Response to RC1

This is a well-written and structured manuscript, easy to read and follow meanwhile without losing the rigour of scientific work. It deals with the evaluation of atmospheric models for simulating solar and wind power in California, with multiple layers of investigation, i.e., evaluating the impact of using different atmospheric models, spatial resolutions, and solar and wind power generation models. Answering these questions would help users to understand the impact of different factors on solar and wind power calculations, and to decide on the best solution given the available resources. This is particularly important in the context of the current global transition toward a carbon-neutral energy system. I believe this manuscript could be further improved by addressing the points listed below:

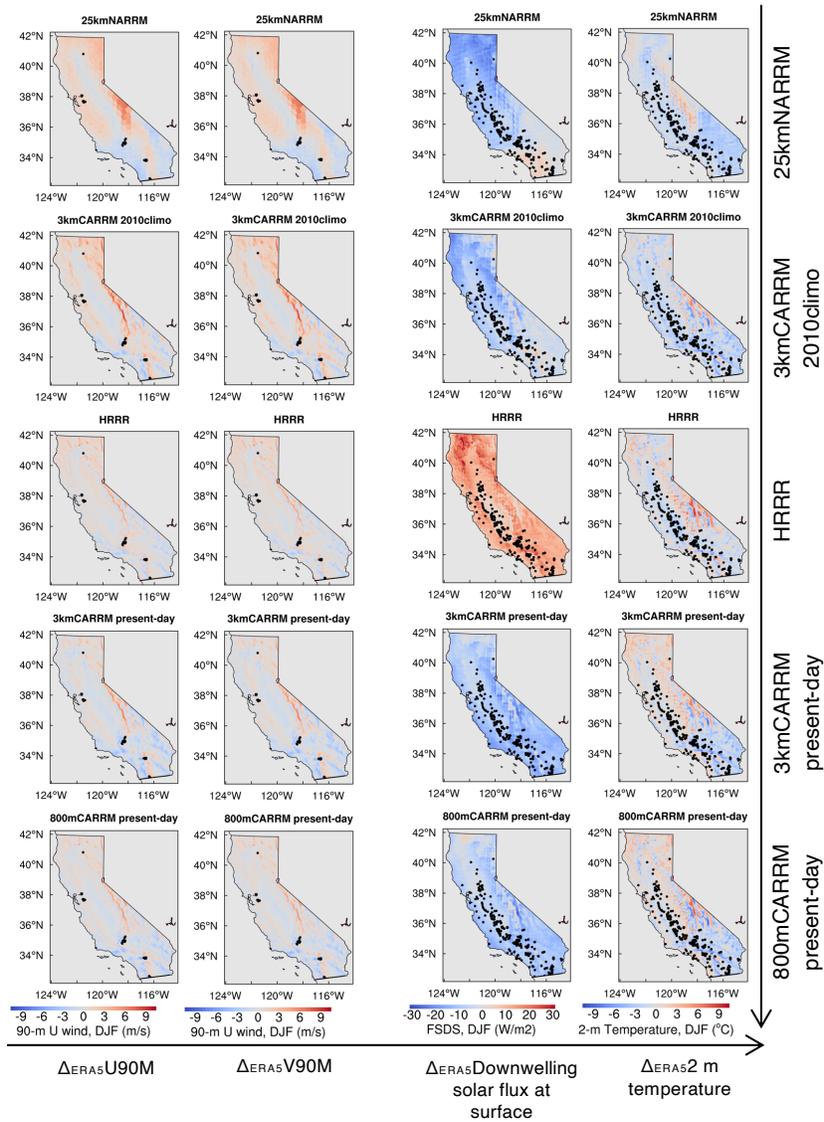
14. Figure 14: why not showing the "difference" subplots you have in Figure 7?

For figures intended to display and preserve the original high-resolution information, we did not include difference plots, because difference maps between simulations at different resolutions tend to be very noisy, especially at higher resolution. Therefore,

we did not include difference maps for the California regional plots in current Figs. 8 and 15. In contrast, for the global circulation plots we included difference maps because the data were first regridded to the ERA5 0.25° grid, which is appropriate for examining large-scale circulation. Nevertheless, we provide here the difference maps (relative to ERA5) for 90-m U/V winds, surface downwelling solar flux (FSDS), and 2-m temperature, with all data remapped to the 3kmCARRM physical grid:
